Permitting decisions

Variation

We have decided to grant the variation for McCain Scarborough Manufacturing Site operated by McCain Foods (G.B.) Limited.

The variation number is EPR/BO7732IZ/V006.

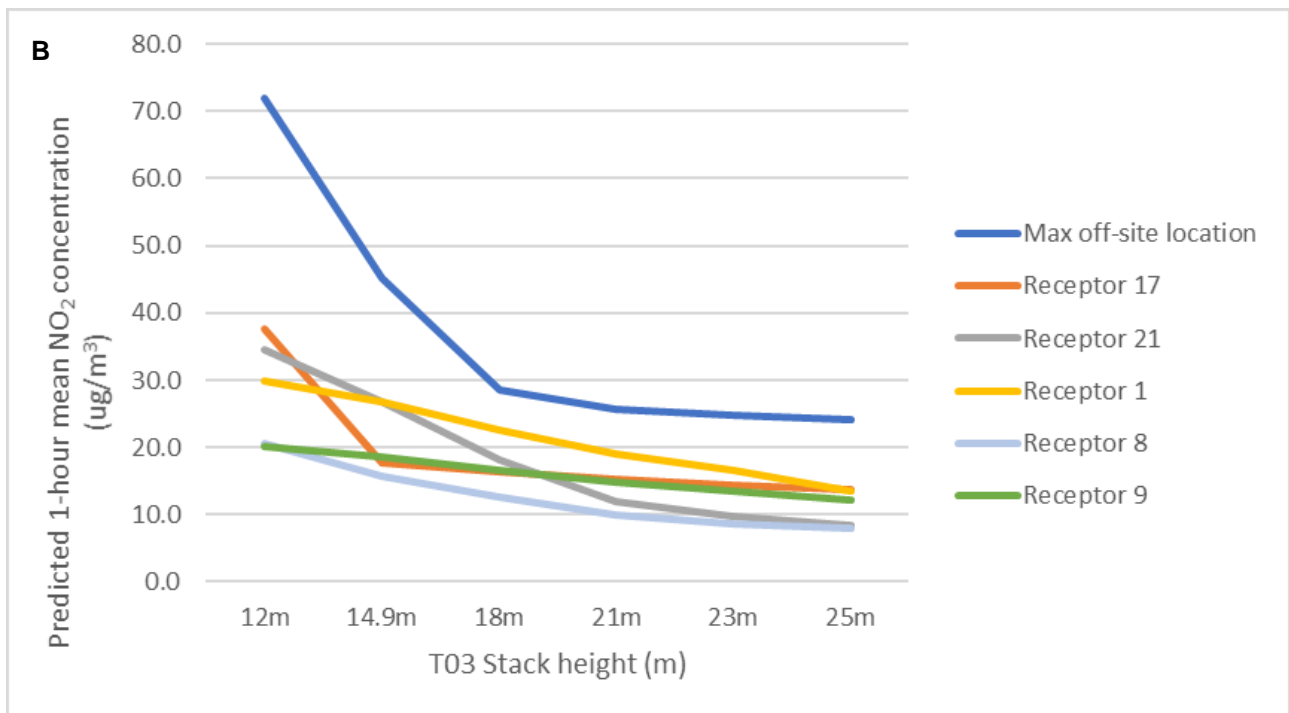
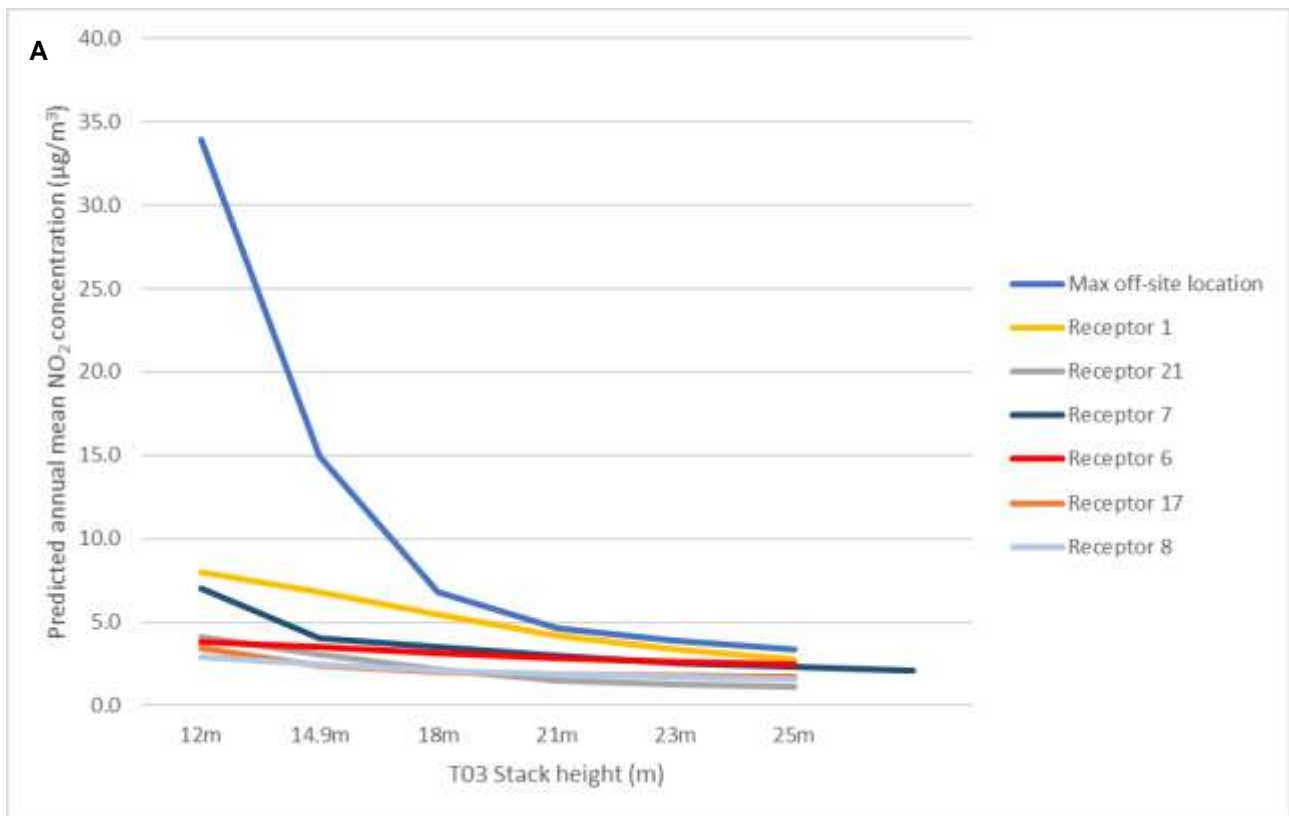
The Stack Height Assessment Memorandum (1 February 2019) demonstrates that increasing the thermal oxidiser stack height from 14.9 m to 18 m significantly reduces building downwash effects. Figure 1 demonstrates a noticeable decrease in the overall installation NO₂ PCs (i.e., considering all emission points on site) at receptors with an increase in thermal oxidiser stack height from 12 to 18 m, then a lower rate of decreasing NO₂ PCs at receptors above 18 m. Table 6 shows the results of the detailed NO₂ atmospheric dispersion modelling for the most impacted human and environmental health receptors under both the short term and long term exposure periods with a thermal oxidiser stack height of 18 m. The NO₂ PCs remain >1% of the long term EQS and >10% of the short term EQS (and therefore are not considered insignificant), but there is adequate headroom between the PECs and the long term and short term EQSs. The Stack Height Assessment Memorandum (1 February 2019) also details that to increase the thermal oxidiser stack height above 18 m significantly increases the associated costs (from an additional £10,000 to an additional £600,000). Our audit agrees with these conclusions (AQMAU-C1771-RP01; 21 February 2019).

In summary, all emissions either screen out as insignificant for human health risk or, where they do not screen out as insignificant, they are considered unlikely to give rise to significant pollution. We agree that a thermal oxidiser stack height of 18 m is BAT.

Figure 3: Negligible decrease in predicted NO_x PCs at Cayton, Cornelian and South Bays SSSI considering all emissions on site, with increasing thermal oxidiser stack height (taken from Stack Height Assessment Memorandum; 1 February 2019; H2b, H2c, H2a and H2d are receptor sites within the SSSI).

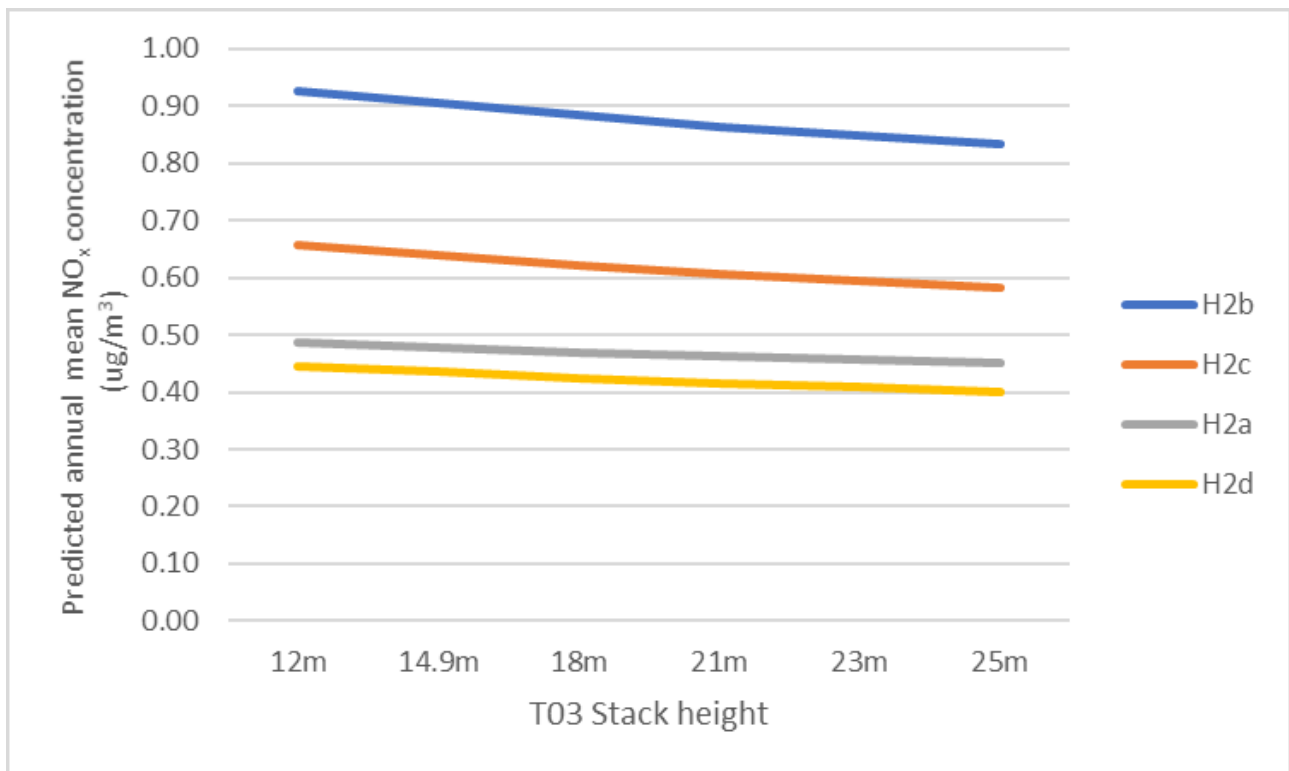
The Stack Height Assessment Memorandum (1 February 2019) modelling, with a stack height of 18 m, NO_x PCs >1% of the long term C_{Le} EQS at each of the four SSSI receptor sites (Table 7). Therefore we could not initially screen out these long term PCs as insignificant. The NO_x PECs were all <41.7% of the long term C_{Le} EQS. Therefore we consider there is adequate headroom between the PECs and the long term C_{Le} EQS. The short term NO_x PCs of the installation at the SSSI are <10% of the short term C_{Le} EQS (Table 7); therefore these emissions have been screened out as insignificant.

In conclusion, all emissions either screen out as insignificant or, where they do not screen out as insignificant, they are considered unlikely to give rise to significant pollution with a thermal oxidiser stack height of 18 m, which is considered BAT for this installation.
